Access Compliance Report

Public Rights-of-Way

(Curb Ramps)

Intersection ID: 44232	Main Street: PAPER_BIRCH_DR	Cross Street: MAIDENHAIR_CT	Location: SE
ADA ID: 1CF3EB1B683D	Ramp Type: Perp	Initial Pass/Fail: Fail	Overall Compliance: No
Severity Score: 12.5			
Codes/Mitigation Info/Possible Solution		Field Measurements/Component Compliance

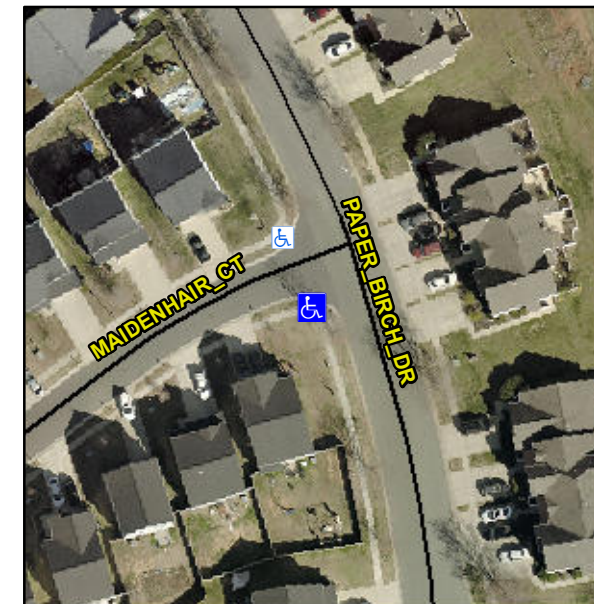
Not Found, R304.5.3

Compliance	Description	Data	Compliance	Description	Data
N/A	Ramp Length (in)	47.5	Yes	Ramp Slope (%)	7.2
Yes	Ramp Width (in)	48.0	No	Ramp XSlope (%)	5.4
N/A	Flare Type LT	N/A	N/A	Flare Type RT	N/A
N/A	Flare Slope LT (%)	N/A	N/A	Flare Slope RT (%)	N/A
N/A	Flare Traversable LT?	N/A	N/A	Flare Traversable RT?	N/A
N/A	Landing Length (in)	N/A	N/A	DWS Provided?	N/A
N/A	Landing Width (in)	N/A	N/A	DWS Contrast?	N/A
N/A	Landing Slope (%)	N/A	N/A	DWS Length (in)	N/A
N/A	Landing X Slope (%)	N/A	N/A	DWS Full Width?	N/A
N/A	Landing Curb? (Y/N)	N/A	N/A	DWS Offset (in)	N/A
N/A	Shared Landing?	N/A			
N/A	Gutter Ponding?	N/A	N/A	Gutter Slope (%)	N/A
N/A	Gutter Lip Ht (in)	N/A	N/A	Gutter X Slope (%)	N/A
N/A	Painted X Walk1?	No	N/A	Painted X Walk2?	N/A
	X Walk 1 Direction	To N		X Walk 2 Direction	N/A
N/A	X Walk 1 Width (in)	N/A	N/A	X Walk 2 Width (in)	N/A
	X Walk 1 Slope (%)	1.6		X Walk 2 Slope (%)	N/A
	X Walk 1 X Slope (%)	4.4		X Walk 2 X Slope (%)	N/A

Remove & Replace Entire Ramp.
